PERMIT TO CONSTRUCT AN ON-SITE SEWAGE DISPOSAL SYSTEM
NON-CONFORMING REPAIR

Permit/Asbuilt Number: PT2025-491 185

Address of Construction Site: 4694 WRIGHTSMAN PLACE City: CLINTON

TO: Onsite Team, Environmental Health  
FROM: Alexander Reitz, Public Works Development Coordinator  
SUBJECT: Permit #: PT2025-491 EH-OSS-REPAIR  
Parcel No.(s): S6397-00-00008-0

### Plot Plan

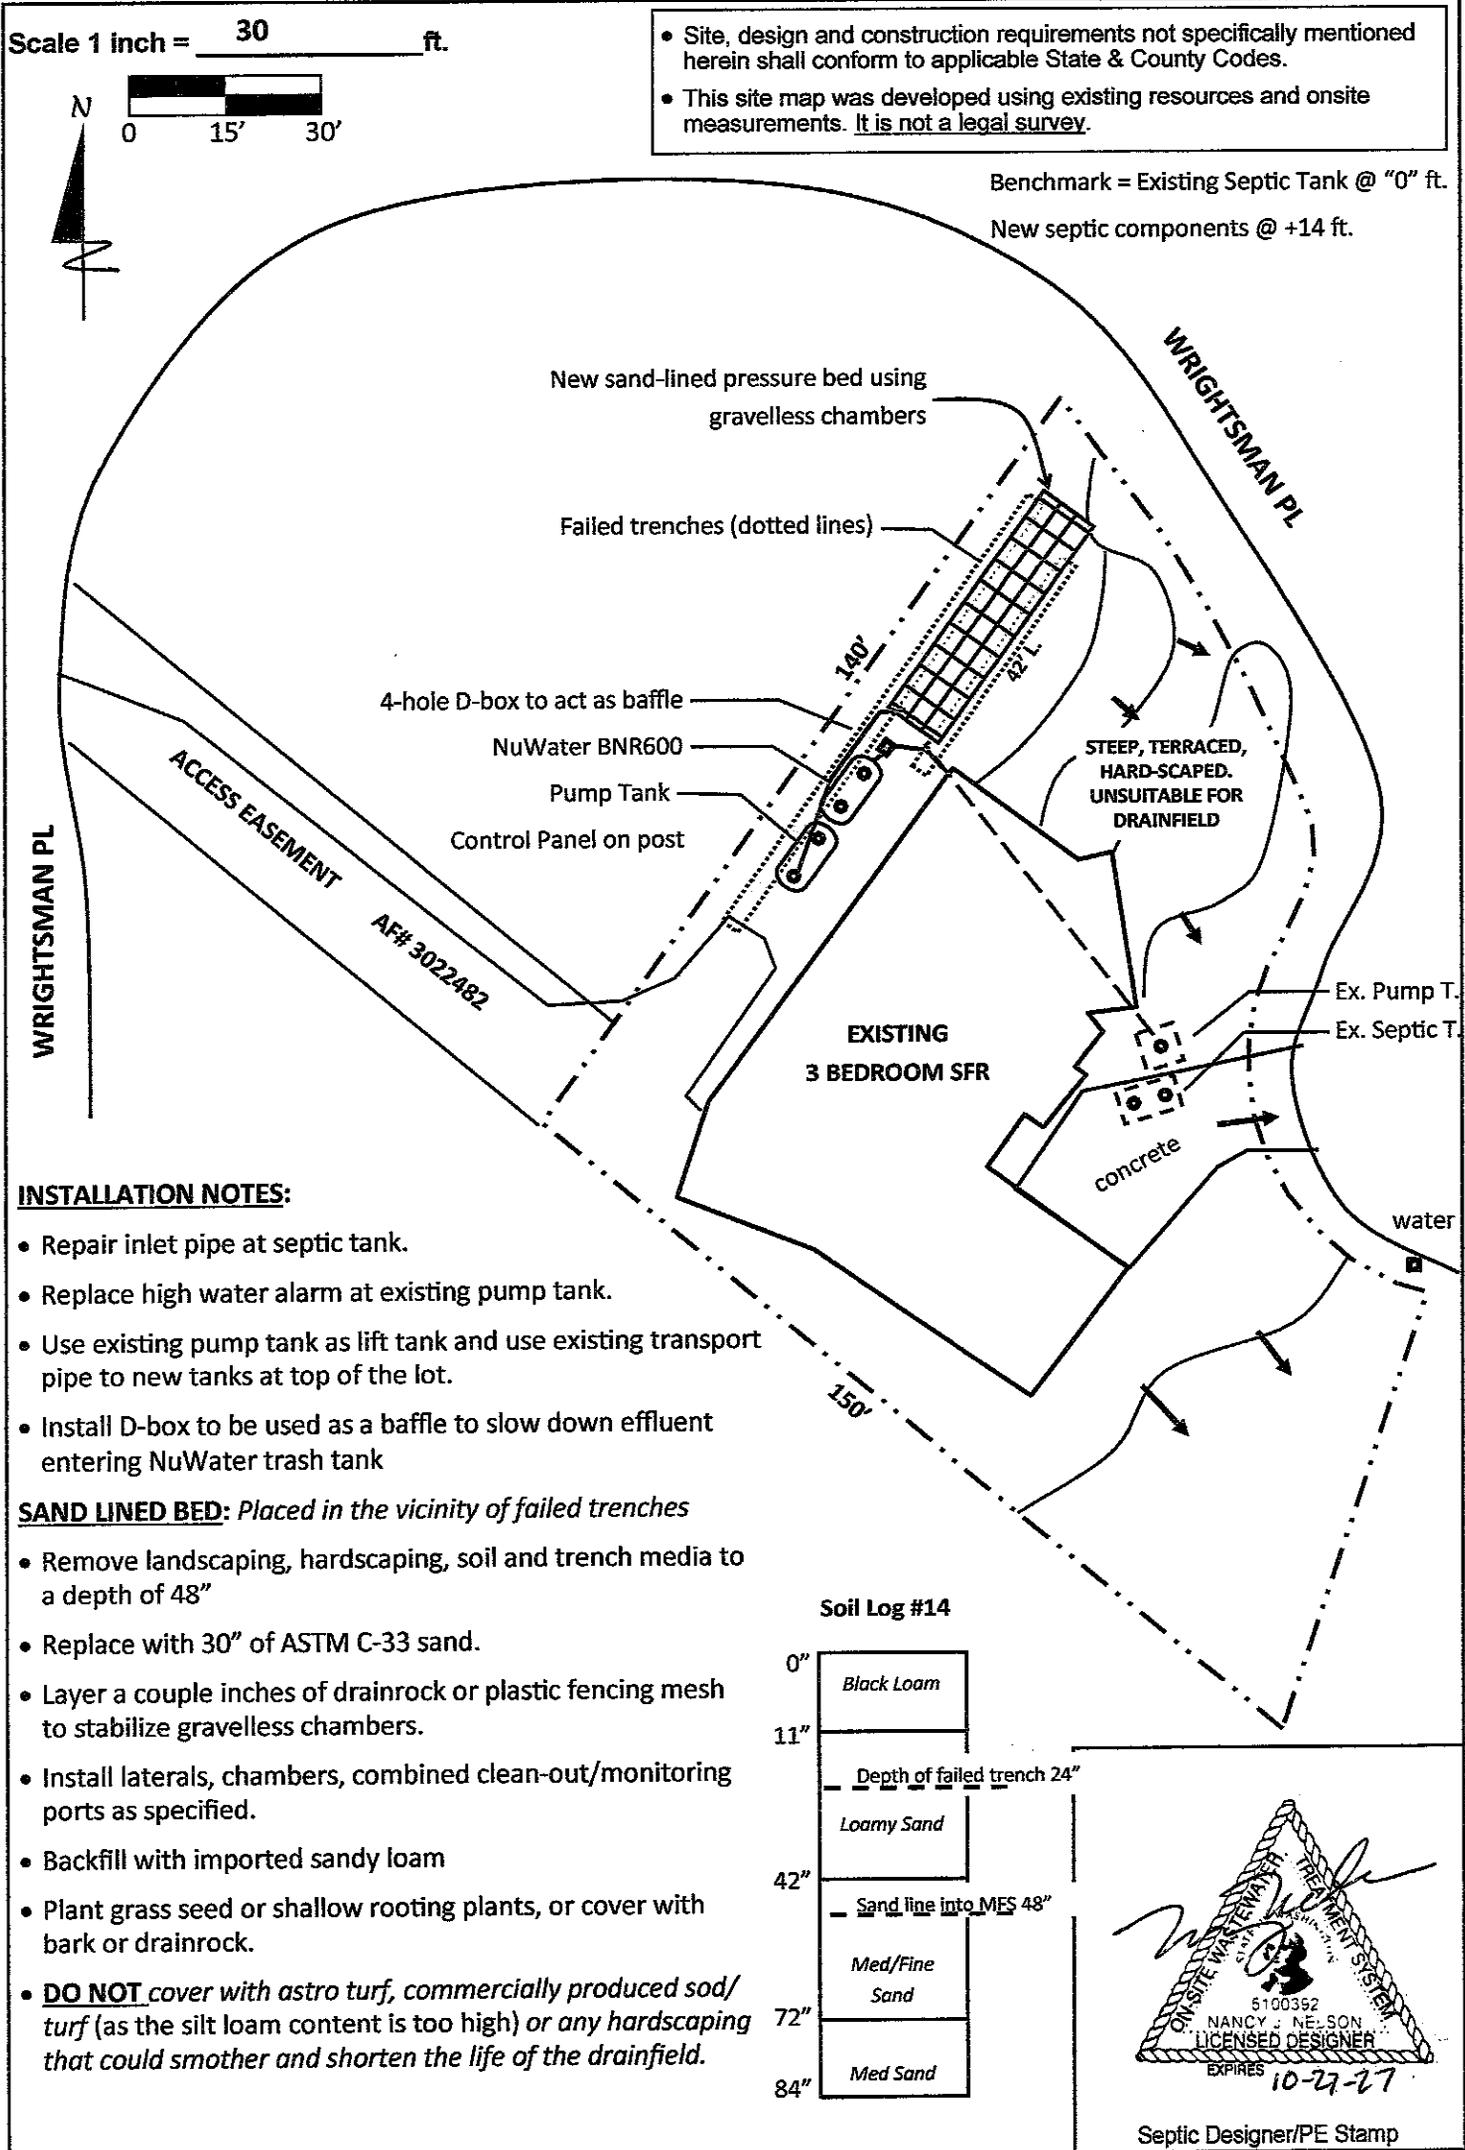
The Applicant wishes to repair an existing septic system on their parcel to support an existing SFR. The parcel is encumbered by steep slopes that appear to be retained and well maintained.

Drainage patterns for the residence are unlikely to change as part of this development. Based on the current arrangement it appears this proposal adheres to ICC 11.02.310 so long as a minimum of a two-foot setback to the parcel lines are adhered to, including the placement of the tanks. Public Works does not require any additional documents for this proposal so long as proper best management practices are utilized during development.

1. Applicant will be expected to maintain a minimum of a 2-foot setback between the septic components and the property lines in accordance with ICC 11.02.310.
2. Appropriate Erosion and Sedimentation Control Best Management Practices shall be employed during all ground disturbing construction activities.
3. Disturbances to Critical Areas or their buffers are not authorized without first obtaining the appropriate permits from the Island County Planning and Community Development Department.
4. The proposed development shall not result in the diversion of surface water, or create new drainage channels, increasing runoff and/or hazard to downslope properties, roads, or critical areas.
